ADDENDUM 2

Flores/Zapata Elementary School Heating & Air Condition (HVAC) Improvements Funded through the Elementary & Secondary Emergency Relief (ESSER) Funds April 28, 2022

Edinburg CISD – Flores-Zapata Elementary HVAC Upgrades

ADDENDUM NO. 2

RTU PLAN
SCALE: N.T.S.

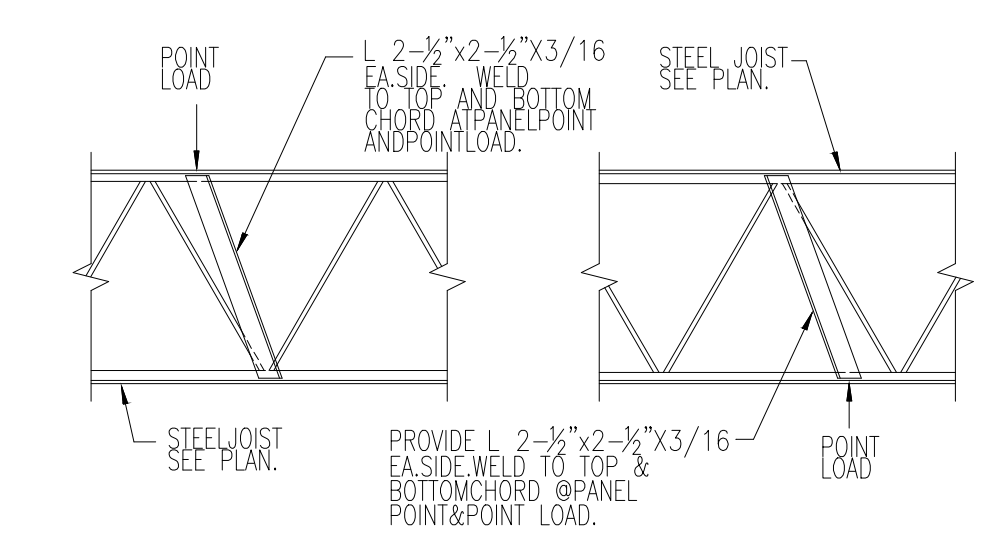
- a) Sheet M2.2:
 - i) Barometric Relief Vents: provide roofing work as necessary to install BRV-1 thru BRV-3 and their associated curbs. Provide structural reinforcement using details 1 thru 4 of the Structural Sheet S2.0.
- b) Sheet S2.0:
 - i) See attached full size 36"x24" structural sheet showing the structural reinforcement scope of work.
